APPLICATION NO.	FILING DATE	FIRST NAMED INVENTOR	ATTORNEY DOCKET NO.	CONFIRMATION NO.
10/614,350	07/08/2003	Masaaki Goto	1046	7857
27649	7590 07/06/2005		EXAMINER	
MICHAEL TOBIAS #40 1717 K ST. NW, SUITE 613 WASHINGTON, DC 20036			TRAN, DUE NGOC	
			ART UNIT	PAPER NUMBER
			2841	
			DATE MAILED: 07/06/2005

## **DETAILED ACTION**

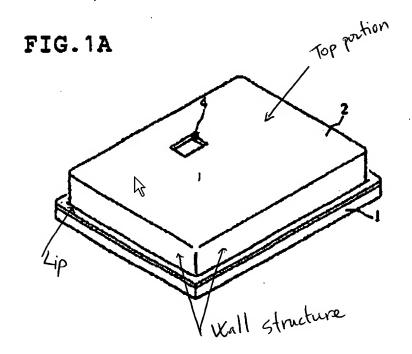
3. With respect to claim 1, Ito discloses a cap-shaped lid for use with a generally flat base to seal an electronic device comprising a top portion (See examiner's figure), a wall structure extending around an entire periphery of the top portion and having an upper end connected to the top portion and a lower end (See examiner's figure), a lip connected to the lower end of the wall structure around an entire periphery of the wall structure and extending outwards from an outer surface of the wall structure (See examiner's figure on the next page), and solder applied to an inner surface of the lid on at least a portion of the lip (Page 7, col. 4, lines 22-23). However, Ito does not disclose expressly wherein the lip extends outward from the outer surface of the wall structure by 10-500 μm.

The Choon reference, however, discloses the lip extending outwards from the outer surface of the wall structure by 10-500  $\mu$ m (Page 5, col.3, lines 59-61).
